INDESIT company

Model type:
BAN12W

Commercial code:
F044458

51520i0 Exploded views

N1030093fig1

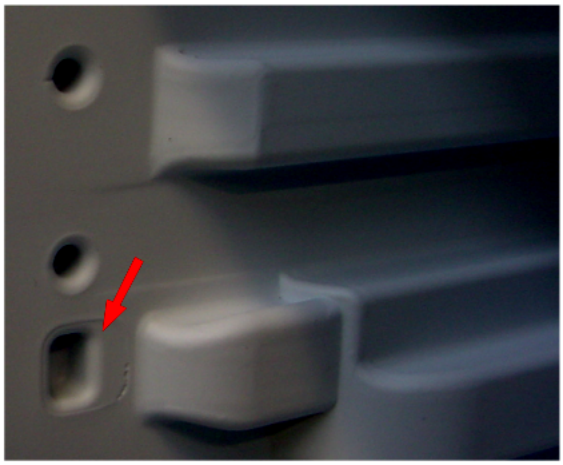
n1030093: New fixing of evaporator on static fridge-freezers (05 range) 60 cm,Melano

From August 05 (serial no. 50802.0001) the freezer evaporator is secured to the cabinet by a plastic profile.
The cabinet walls have been modified to create locations to house the profile, which is installed on the front of each evaporator plate (see photo N1030093fig1- fig2 - fig3)
The profile cannot be fitted on premodification appliances, so technical personnel must continue to fit the rh and lh supports on these models (see photo N1030093fig4)

New parts
C00141135 = WHITE PROFILE L=443.5 MM

Parts replaced
C00075596 = EVAPORATOR RH SUPPORT
C00075597 = EVAPORATOR LH SUPPORT

C00141135
